2018-12-07 DP AMENDMENT REVISIONS

The following is a summary of design revisions since the last DP Submission dated July 25, 2018.

IVY ON THE PARK

DP AMENDMENT SUBMISSION

SITE PLAN

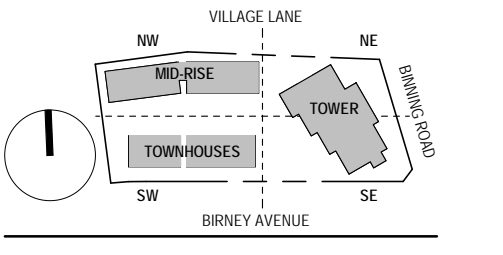
- Site Plan – Mechanical shaft locations revised slightly.
- Landscape North entry to Mid-rise revised.
- Patios to the North of the Mid-rise and Townhouses made larger to accommodate bbqs.

- Guardrails added to South patios of the Mid-rise and Townhouses.
- Walls at patio entry gates revised.

FLOOR PLAN - PARKING
- LEVEL P1

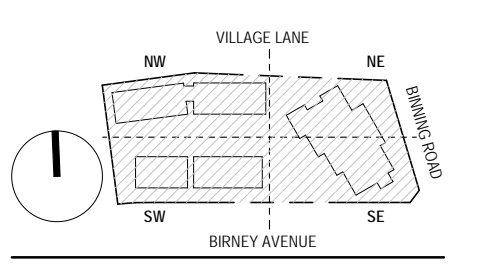
- Level P1 - Additional bike storage added to meet requirements for additional suites.
- Two regular parking stalls moved from P1 to P3. One small car stall added to P2 and one added to P3.

- Handicap parking stall added.
- Sub Electrical room added.
- Two private garages combined into one and two parking stalls removed to meet requirements for townhouse parking.

- Fire Pump room separated from Sprinkler/Water Entry/District Energy Room.
- Level P2 – Mechanical room vestibule deleted adjacent to Mid-rise elevator.

FLOOR PLAN - PARKING
- LEVEL P3

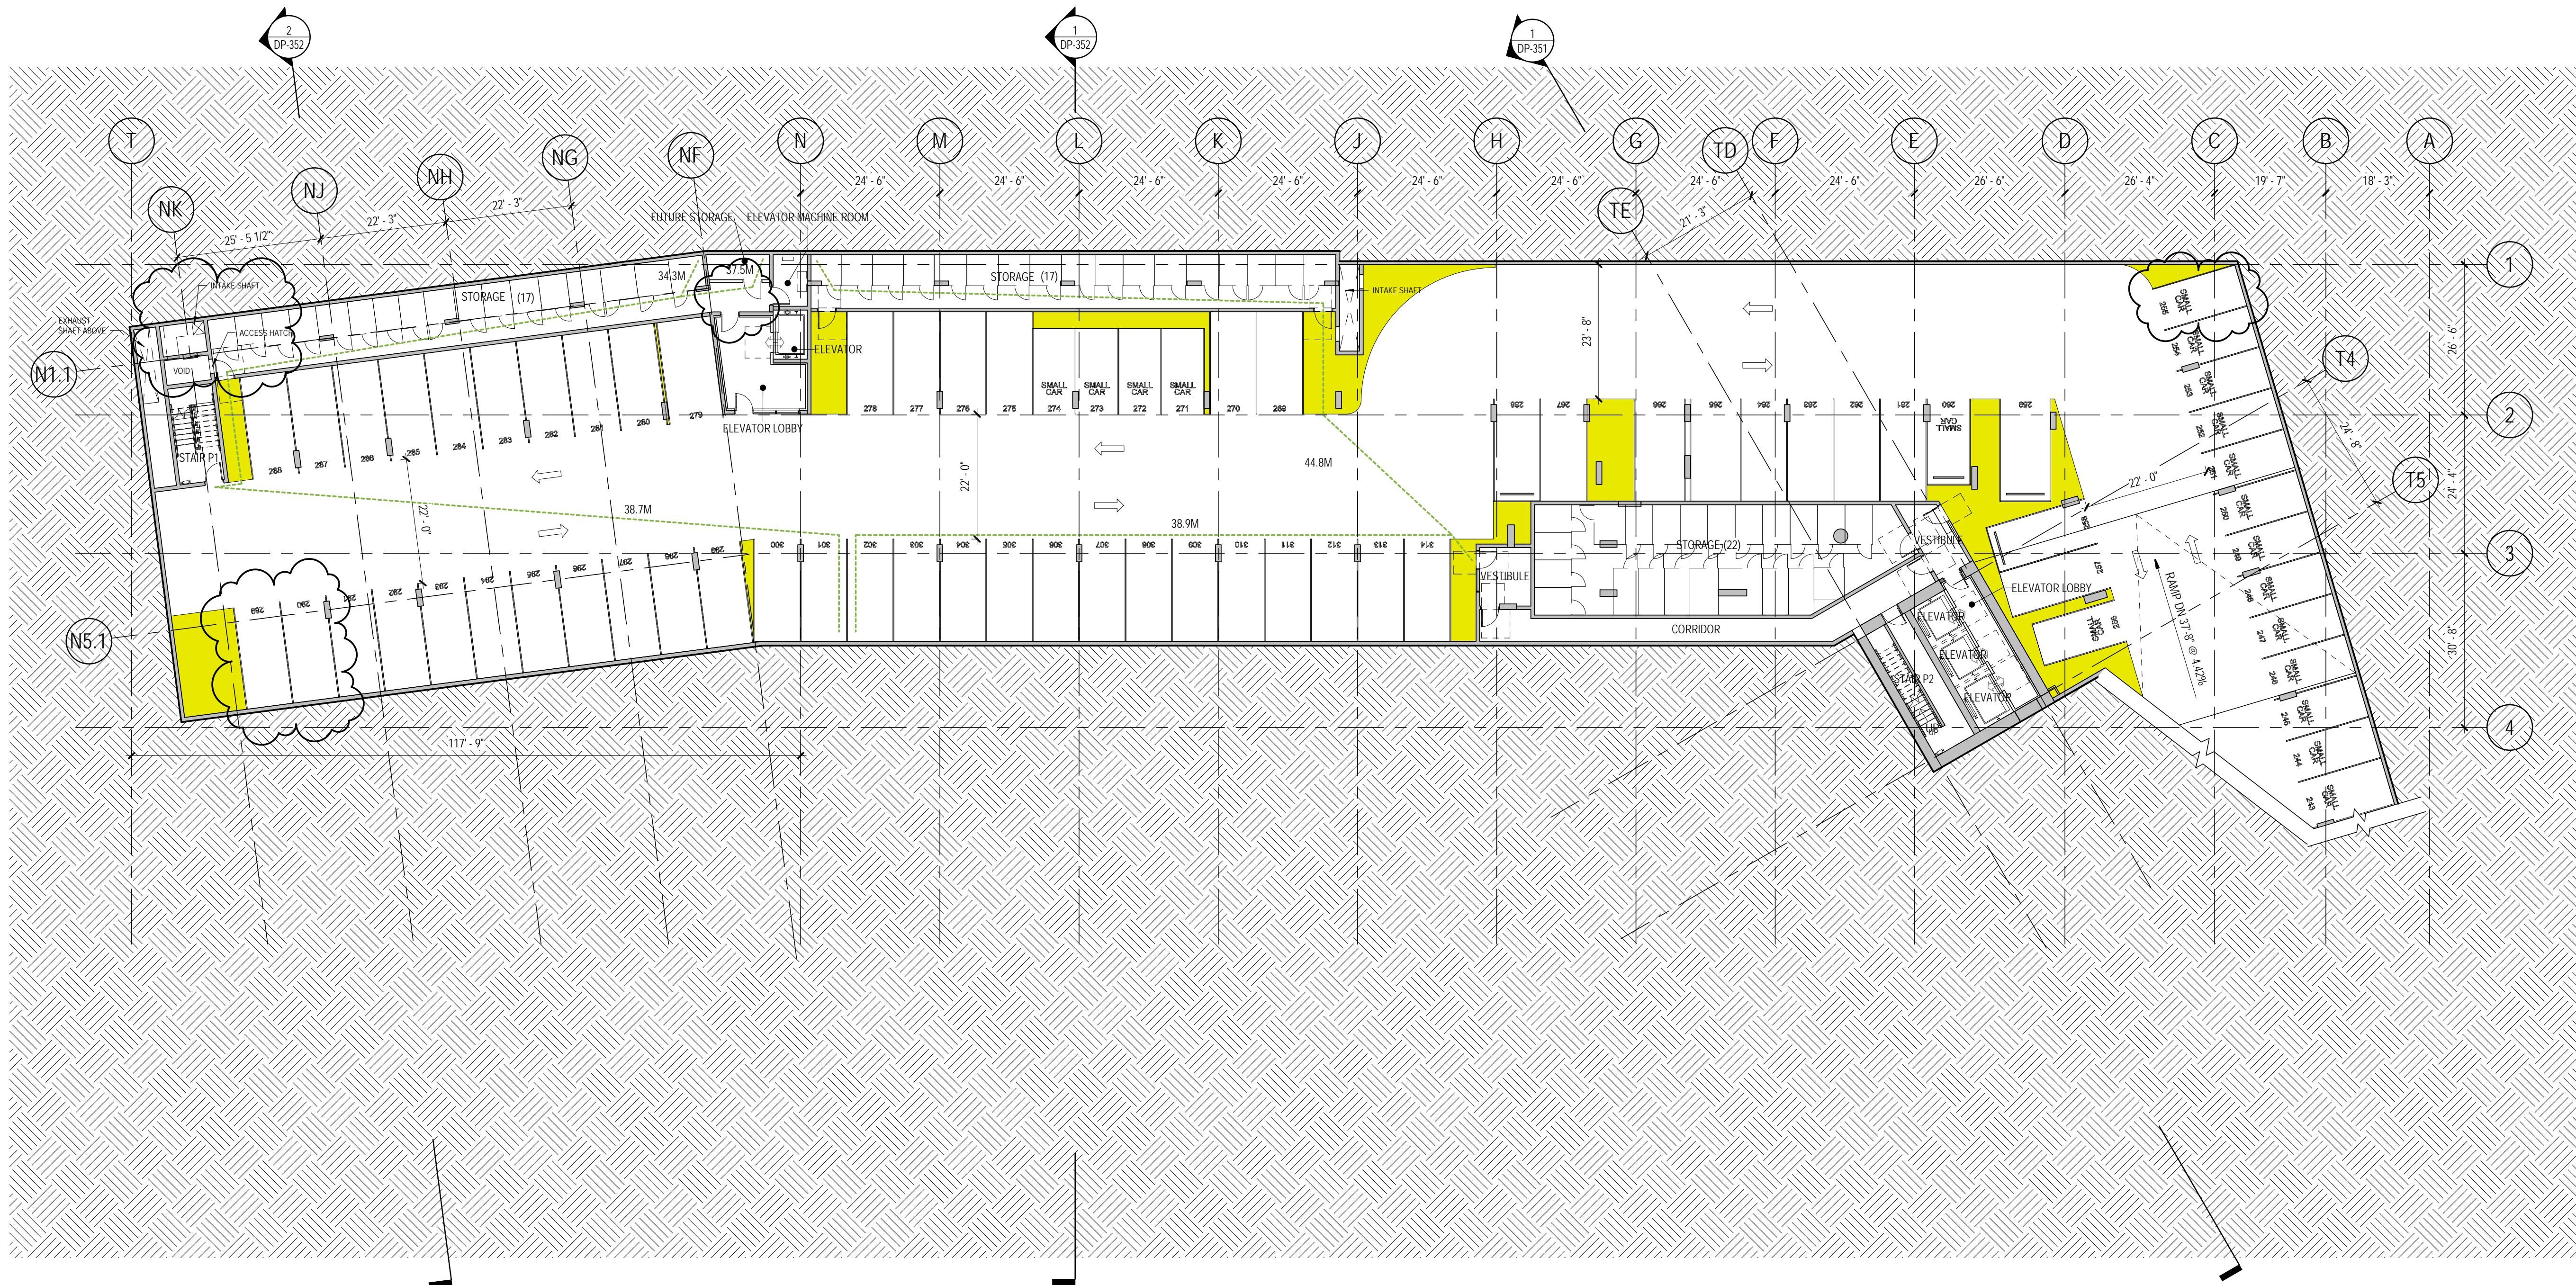
- Mechanical shaft enclosure added for Main Generator.
- Level P3 – Revision of doors to storage areas on the North side.
- Access hatch added to mechanical shaft.

FLOOR PLAN - TOWER -
LEVEL 01

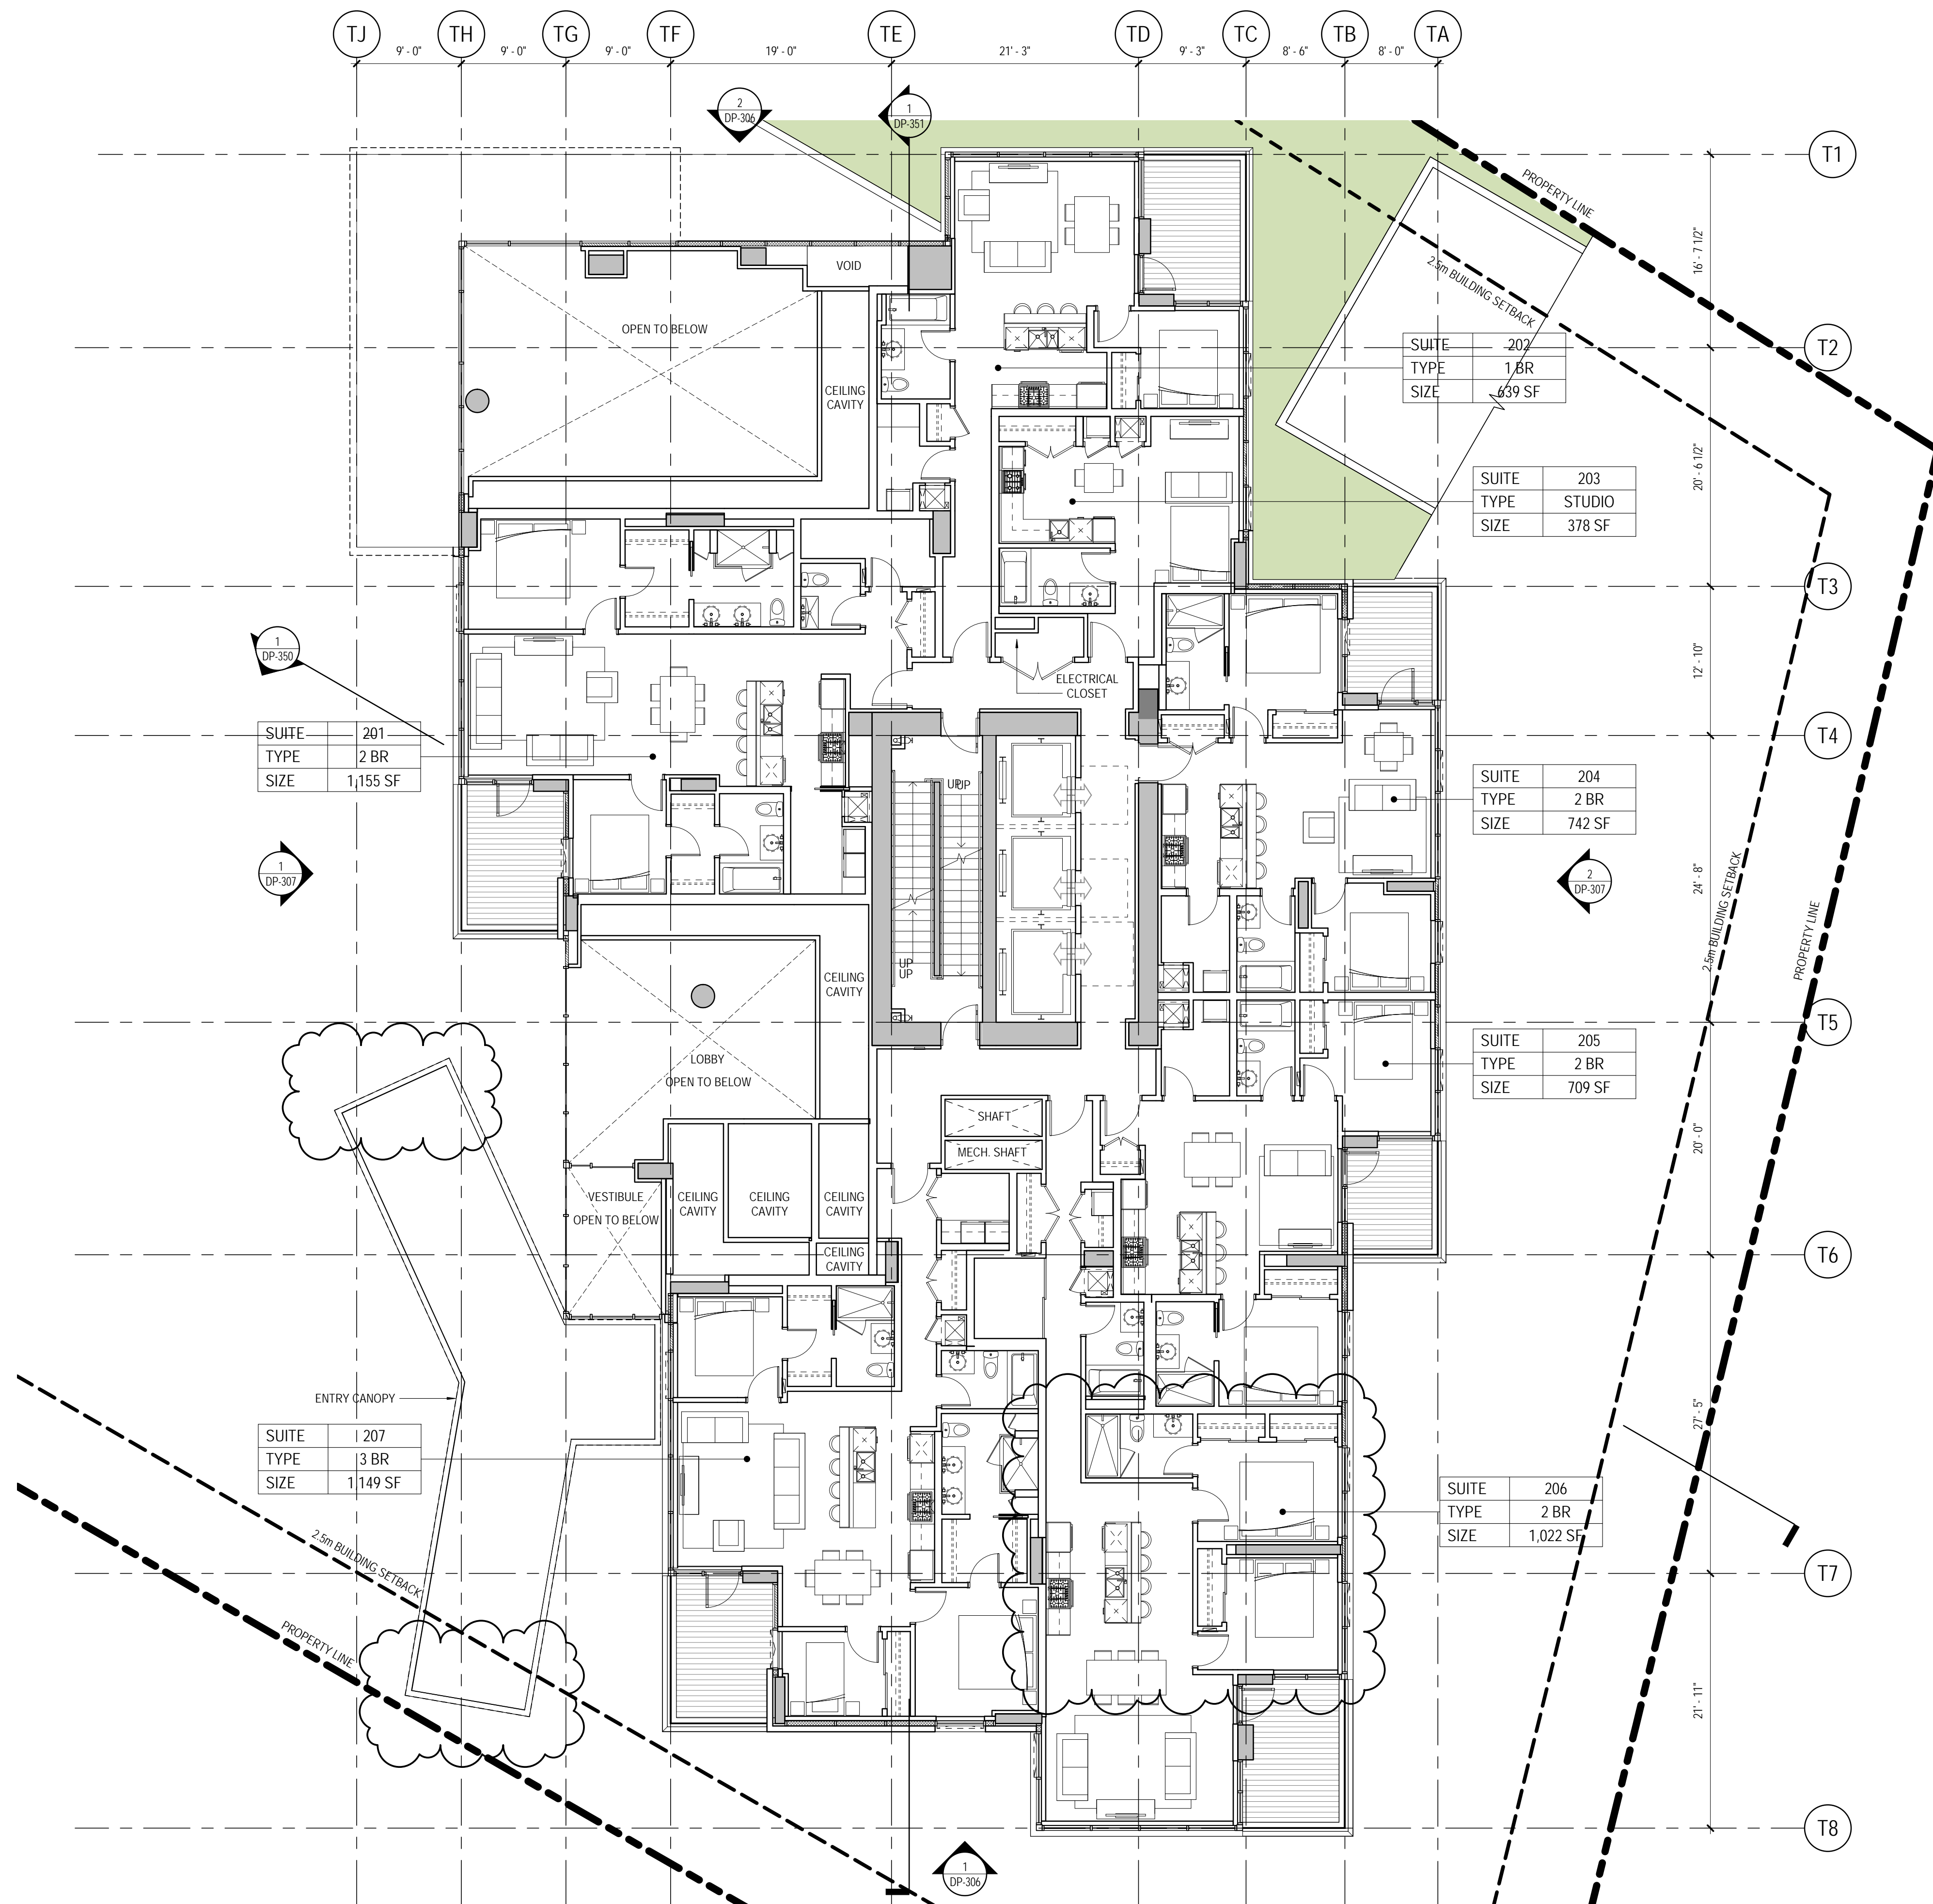
- Column arrangement in the North-West area revised.
- North elevation revised due to suite changes.
- Tower Level 1 – Mail room expanded to accommodate additional suites.

- Electrical closet revised.
- Suite 101 revised from 2 Bedroom suite to a 1 Bedroom suite and additional area being utilized by the Fitness room.
- Entry canopy ends squared off in shape.

FLOOR PLAN - TOWER -
LEVEL 02

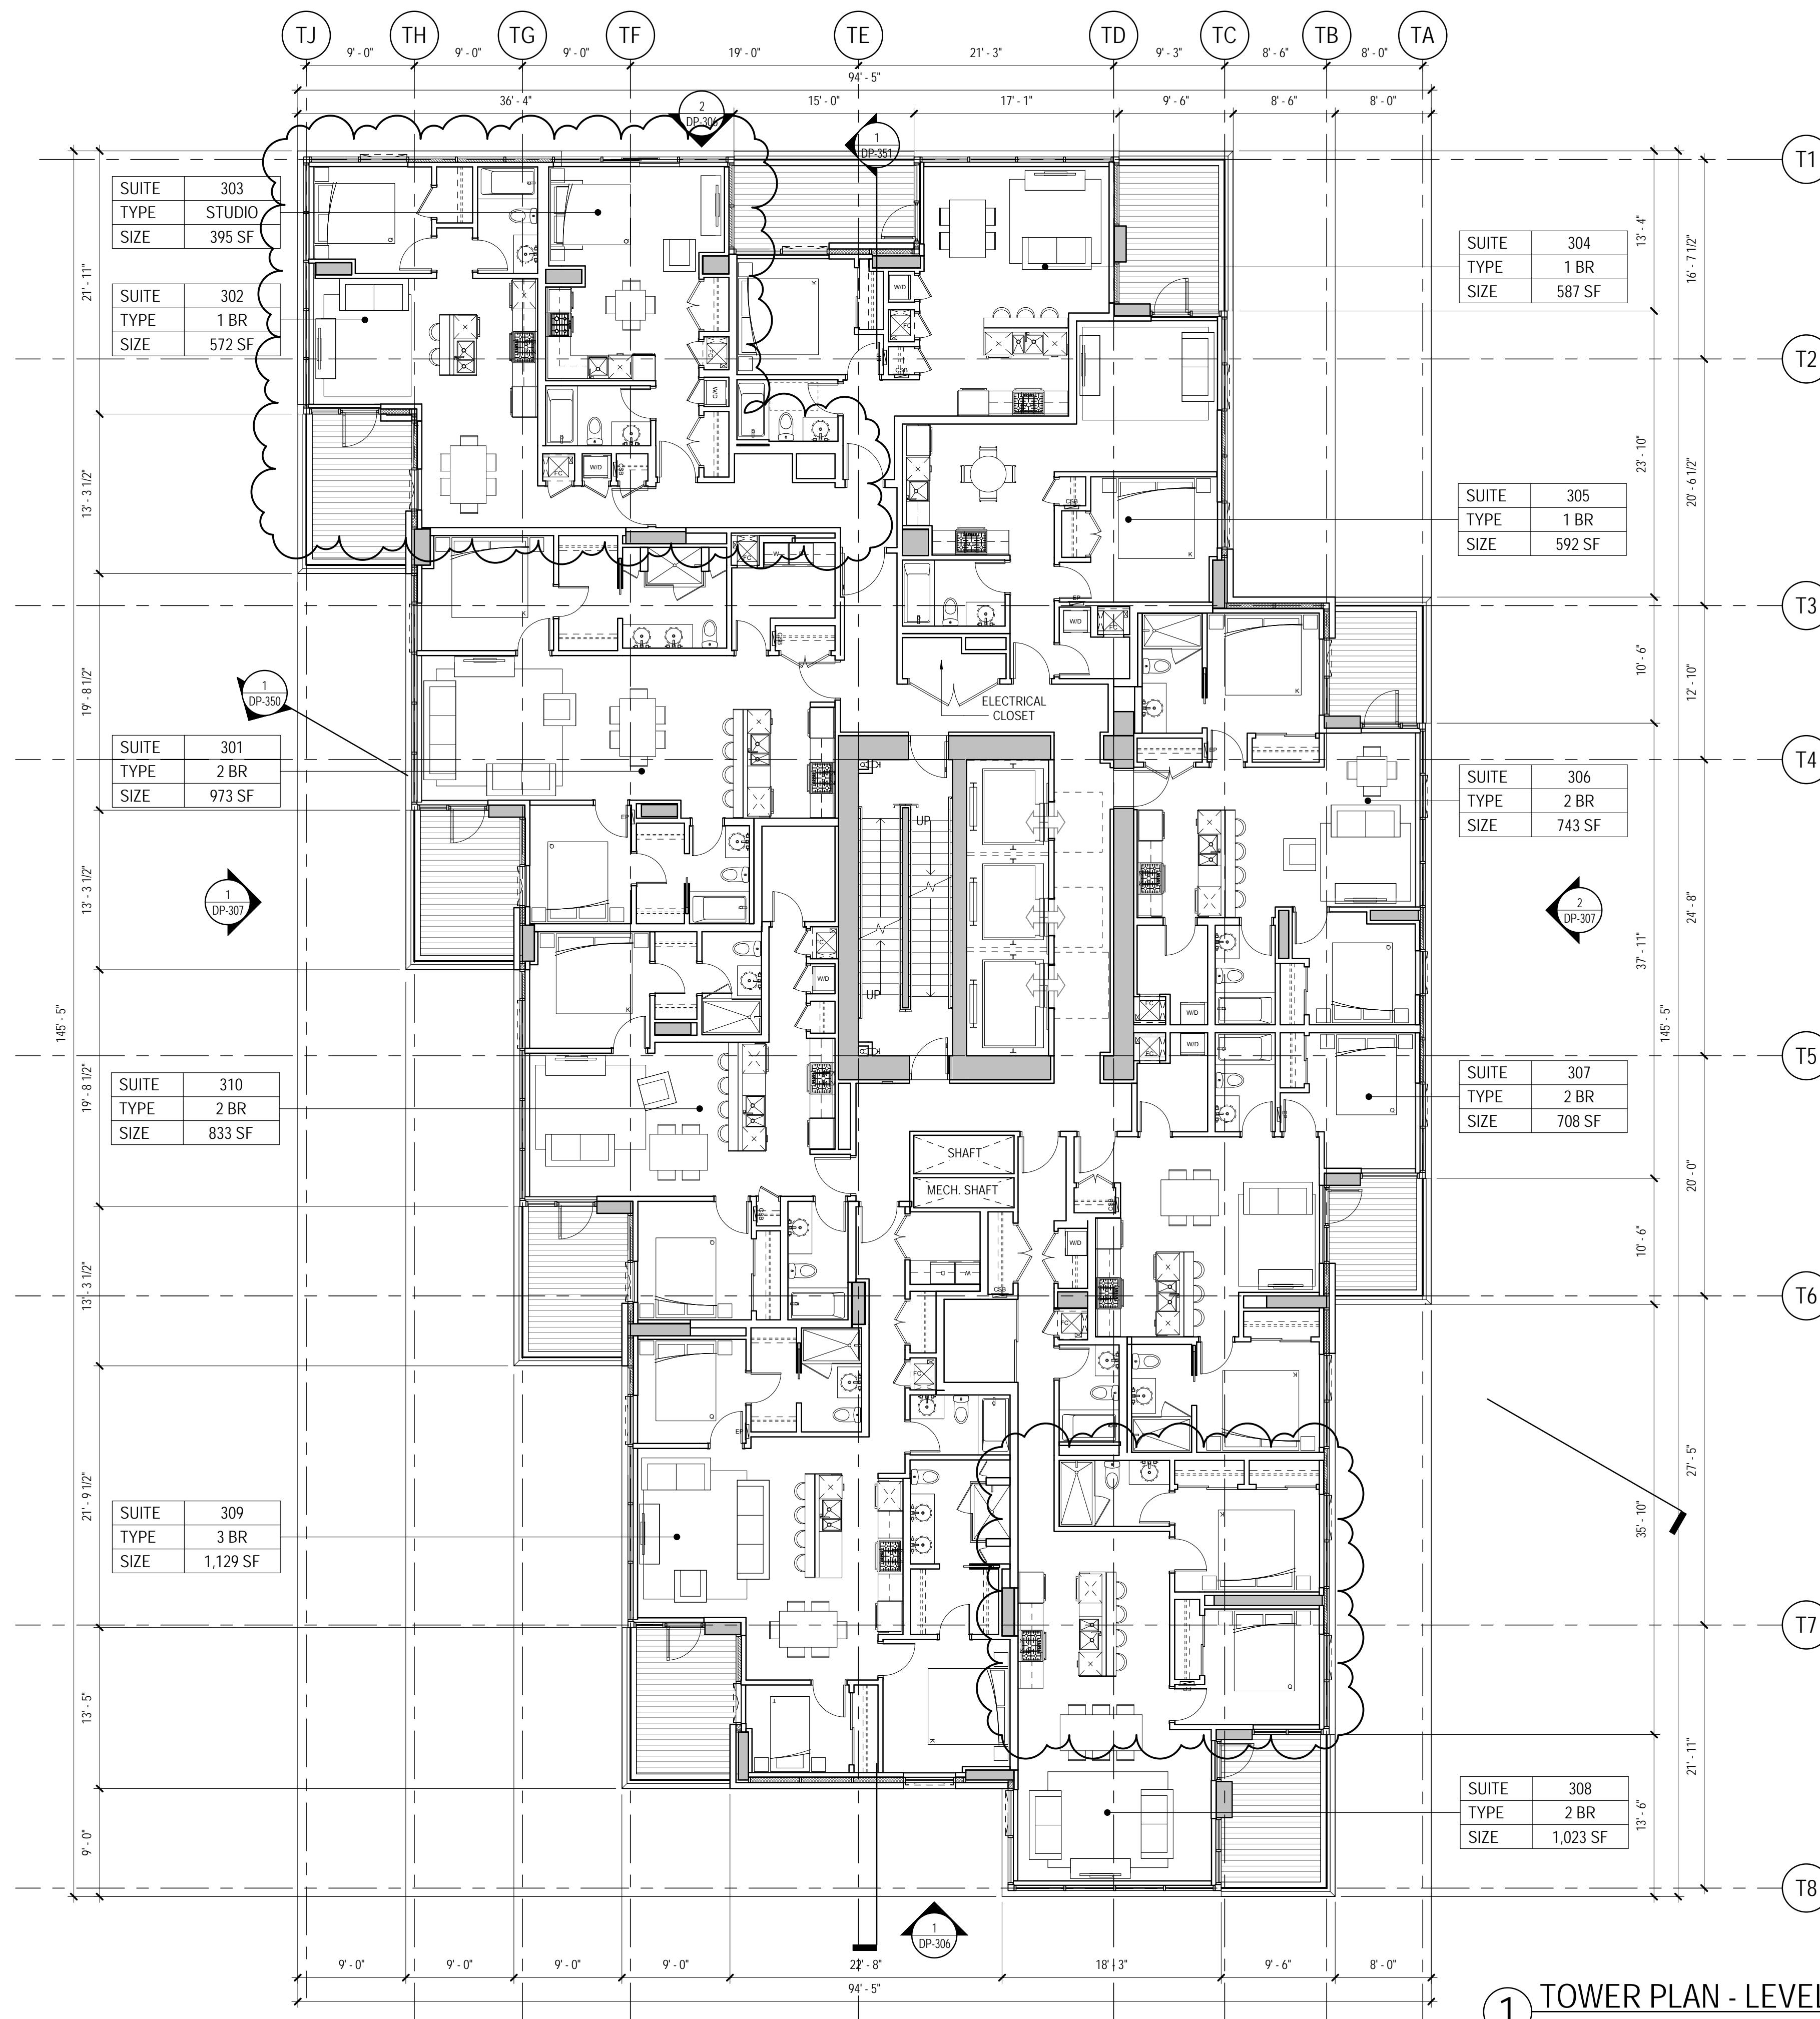
- Tower Level 2 – Kitchen and ensuite location revised in Suite 206 (change applies to levels 2 – 21).
- Tower Levels 3-10 – 2 bedroom unit at North-West end of tower replaced with one 1 bedroom suite and one Studio suite. Some balcony reclaimed at north end by the Studio suite. A Juliet balcony provided to the Studio suite.
